re: Geotechnical Review of Grading and Servicing Plans
Proposed Multi-Storey Building Complex
1009 Trim Road, Ottawa
to: Starwood – Martin Chénier - chenierm@live.ca
date: August 20, 2026
file: PG5336-MEMO.06 Revision 2

Grading Plan Review

Servicing Plan Review

PG5336 - FIGURE 1 - PROPOSED LIGHTWEIGHT FILL PLAN

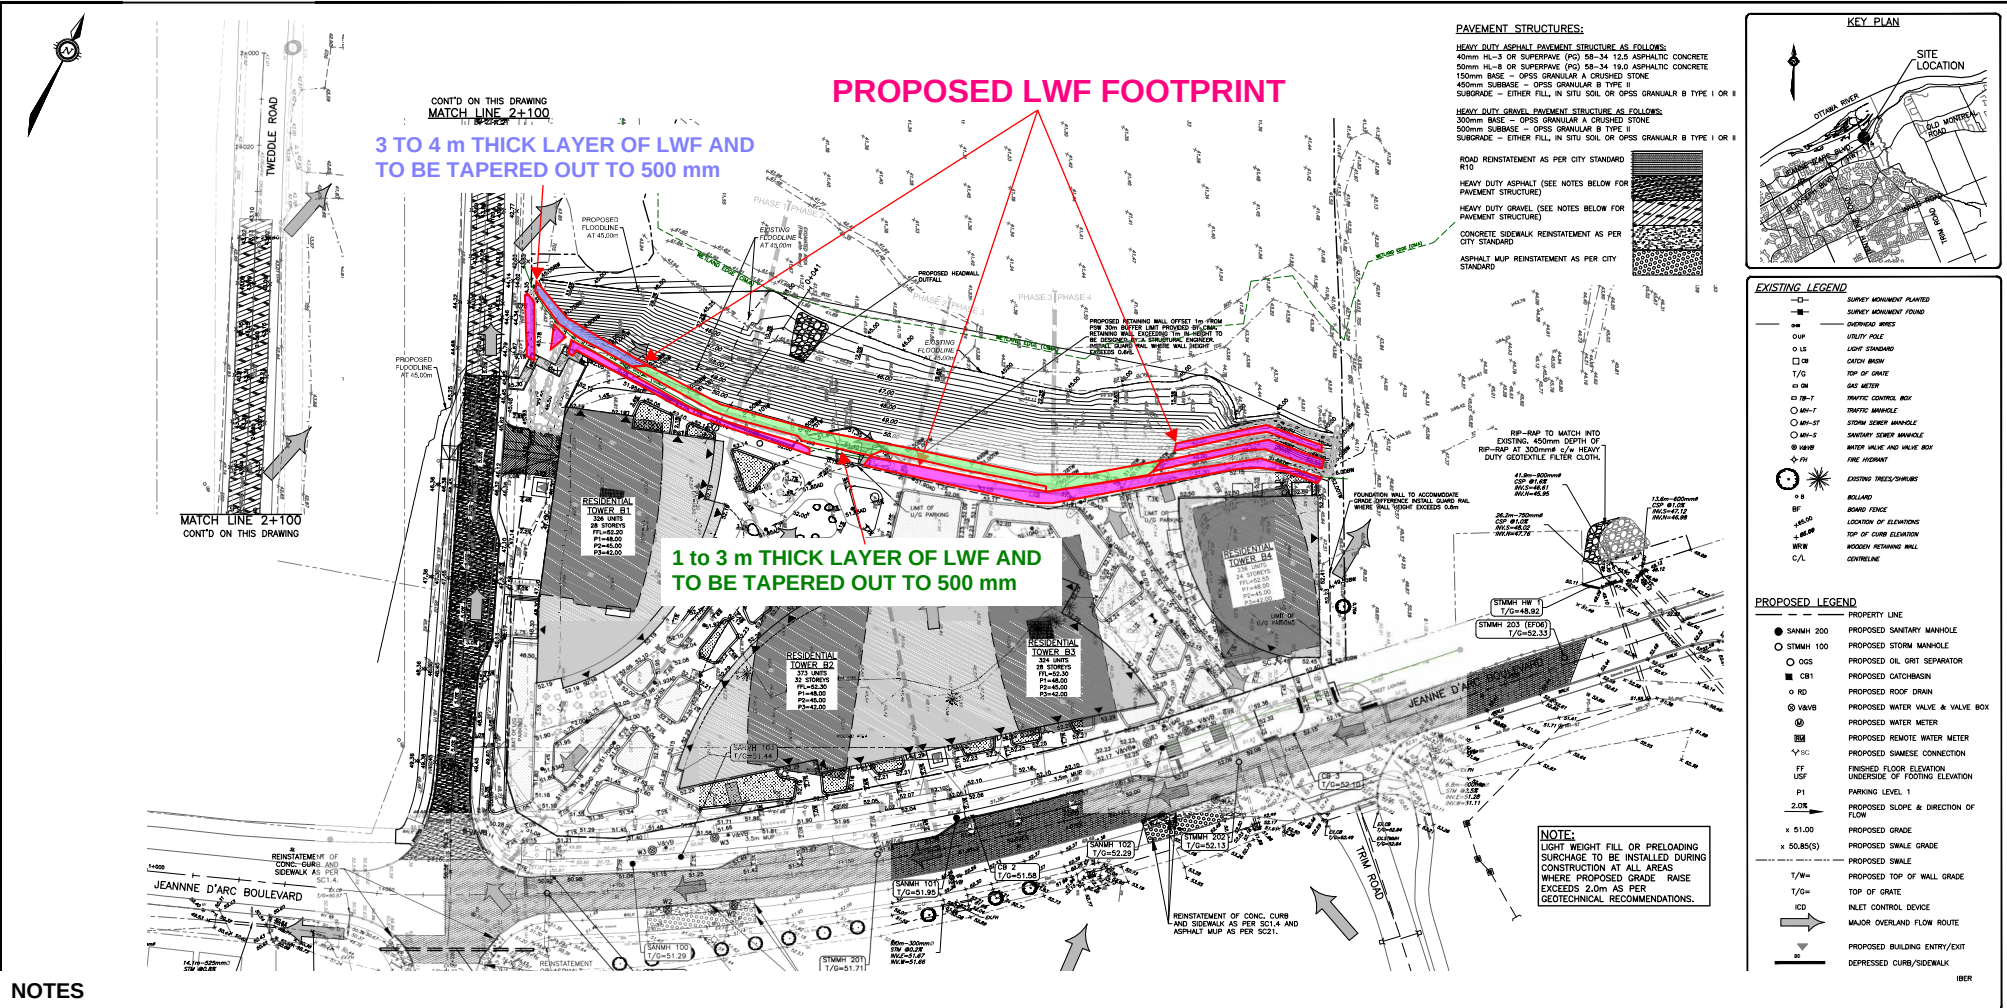
However, some grade raise exceedances were identified in throughout the sloped portion of the development area north of the proposed structure in proximity to the proposed retaining wall structure. This grading and the associated exceedances have been considered in the assessment of the global stability of the proposed retaining wall structure (reference should be made to Paterson Global Stability Analysis memorandum PG5336-MEMO.07 Revision 1 dated March 9, 2026).

Based on that review, lightweight fill (LWF) is recommended to be placed within the backfill of the retaining walls to address the localized exceedances in grading relative to the currently recommended grade raise restriction. Lightweight fill may be assigned across the retaining wall as identified in the *Figure 1 – Proposed Lightweight Fill Plan* attached to this memorandum and as will be detailed and assigned in a manner that is suitably detailed for construction at the time of completing the retaining wall design. The LWF should consist of EPS 12 blocks, with the final thickness profile to be determined following the completion of the retaining wall design. As a general guideline, the thickness of the LWF is expected to range from 1 to 5 m, depending on the area-specific grade raise and geotechnical conditions.

The EPS blocks should be covered with a polyethylene sheet and fully encapsulated in a non-woven geotextile, such as Terrafix 270R, to prevent soil intrusion and protect against degradation. Paterson should be retained to review and monitor the placement of the lightweight fill during construction to ensure conformity with design specifications and to verify field conditions.

Based on the use of lightweight in those areas, the proposed grading is considered acceptable from a geotechnical perspective. The proposed structure has been provided soil cover for protection against frost action, despite the structure being supported by a deep foundation founded at a significantly greater depth than the buildings excavation.
